# UNITED STATES PATENT AND TRADEMARK OFFICE

APPLICATION NO.	FILING DATE	FIRST NAMED INVENTOR	ATTORNEY DOCKET NO.	CONFIRMATION NO.
10/632,449	07/31/2003	Lynn Bich-Quy Le	1229.0001	3797

## Office Action Summary

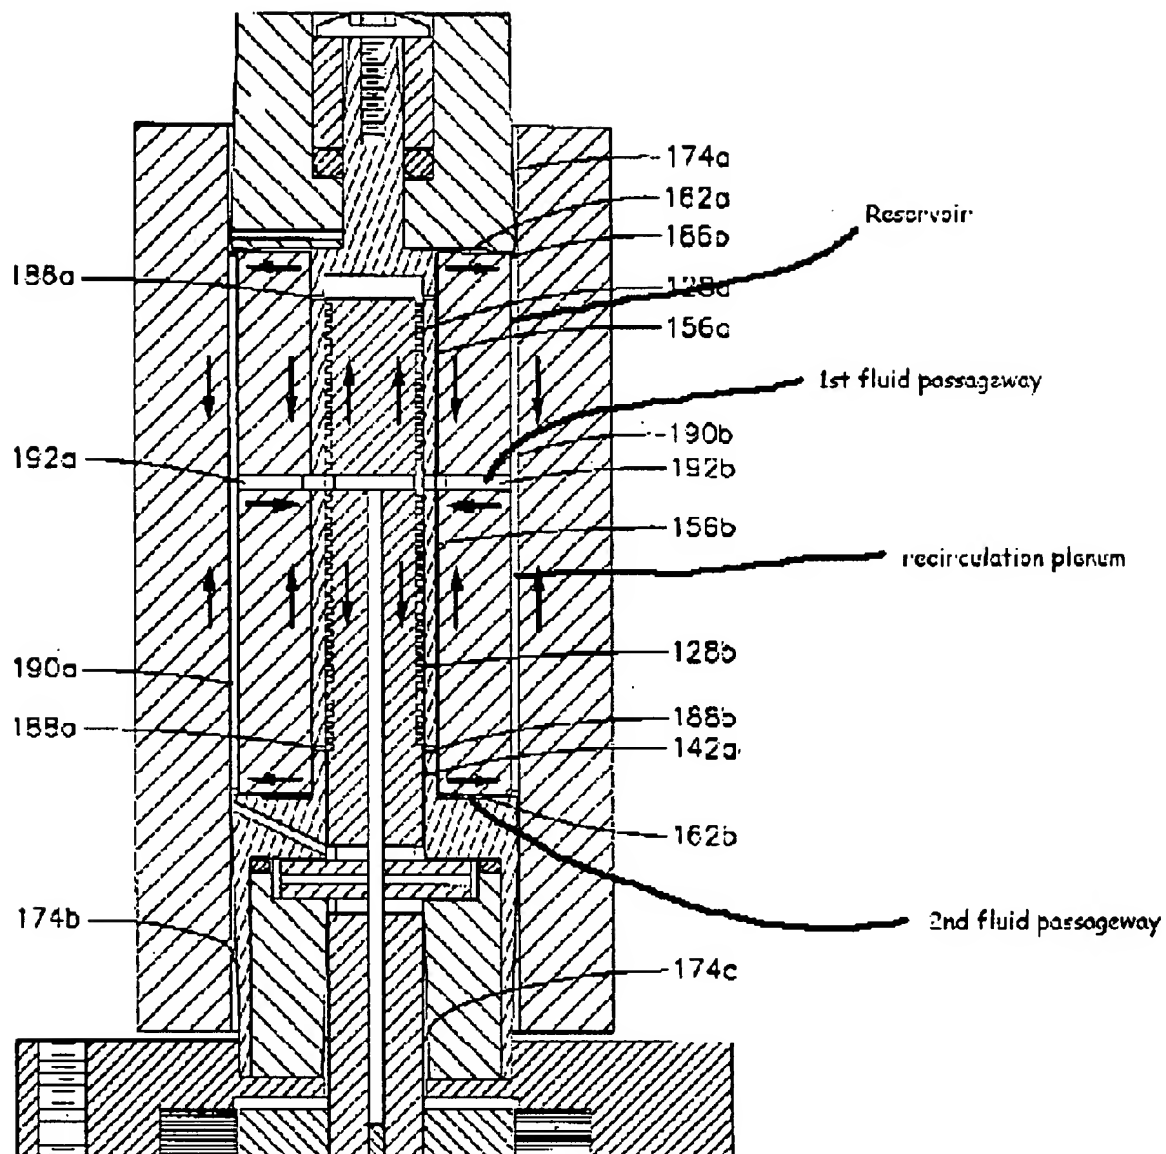
Titcomb discloses a hydrodynamic bearing assembly for use in combination with a spindle motor of a disc drive device comprising:

-a journal bearing (generally 156) defined between an inner component (112) and an outer component (146), which are positioned for relative rotation and define a portion of a stationary component and a rotatable component.

-a fluid recirculation passageway including a first fluid passageway (192) defined within the outer component and in fluid communication with a second fluid passageway

(162b), the second fluid passageway defined between the outer component and a radial member (158b) extending radially from the inner component, the first and second passageways in fluid communication with the journal at separate locations,

-a shield (160) affixed to the stationary component, defining a reservoir (190) with the outer component, and a recirculation plenum is defined by a junction joining the reservoir, the first fluid passageway and the second fluid passageway, and means for sealing the reservoir.

Regarding claim 31, the inner component is a shaft, the outer component is a sleeve.

Regarding claim 32, the first fluid passageway is defined through a sleeve (146).

Regarding claim 33, the second fluid passageway is defined between the outer component and the thrust plate.

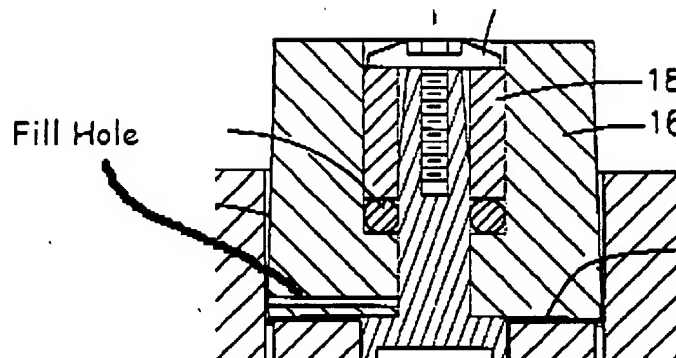
Regarding claim 34, the device comprises means for creating an asymmetric pressure gradient within the fluid recirculation passageway (see fig 7), circulating fluid and purging air in the fluid, wherein the fluid circulates about a substantial portion of the journal, the first fluid passageway and the second fluid passageway (see figure 3).

Regarding claim 35, the shield and outer component form adjacent surfaces, the adjacent surfaces are relatively tapered (creating gap 174a) and converge toward the recirculation plenum.

Regarding claim 19, a fill hole (see fig below) is defined within the shield, wherein a meniscus is positioned between the fill hole and the fluid in the reservoir, the fill hole making an angle with the surface of the shield.
